UNITED STATES PATENT AND TRADEMARK OFFICE

APPLICATION NO.	FILING DATE	FIRST NAMED INVENTOR	ATTORNEY DOCKET NO.	CONFIRMATION NO.
10/060,300	02/01/2002	Takao Murakami	06753.0495	7085

Office Action Summary

DETAILED ACTION

*Regarding
1-5, 10
Claims*

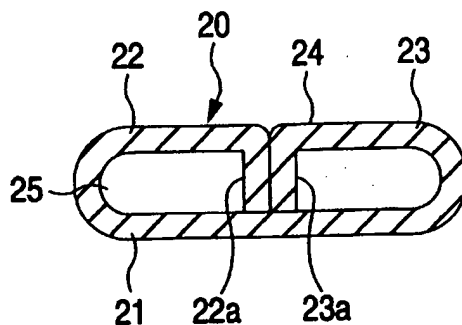
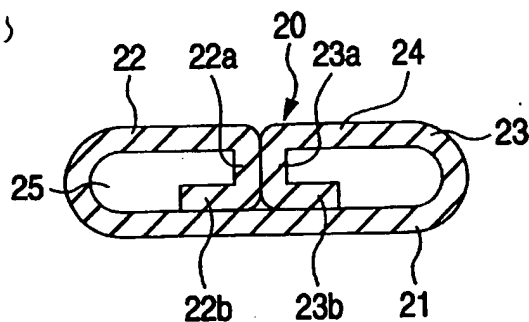
Claims 1-5, 10, 11, 13, 14, and 16 are rejected under 35 U.S.C. 102(b) as being anticipated by Fukuda et al. ("Fukuda"). Per claims 1, 10, 14, and 16, Fukuda discloses a male terminal fitting 1 comprising a plate-shaped contact protrusion 20 formed at one side of said male terminal fitting for mating with a female terminal fitting; and a conductor clamping portion located at the other side of said male terminal for

clamping a conductor of an electric wire; wherein said plate-shaped contact protrusion includes a base plate component (see attachment) longitudinally extending from said conductor clamping portion in an elongated plate shape, an overlapping fold plate component laterally extending from one side of said base plate component and folded to overlap with said base plate component, and a flatness securing plate component overlapping with said base plate component and said overlapping fold plate component to ensure flatness conditions of said base plate component and said overlapping fold plate component.

Per claim 2, said overlapping fold plate component includes a side plate element (see attachment) upwardly extending from one side of said base plate component in a plane substantially perpendicular to said base plate component, and a top plate element extending from said side plate element in a plane substantially parallel to said base plate component; and wherein said flatness securing plate component overlaps said base plate component and said top plate element.
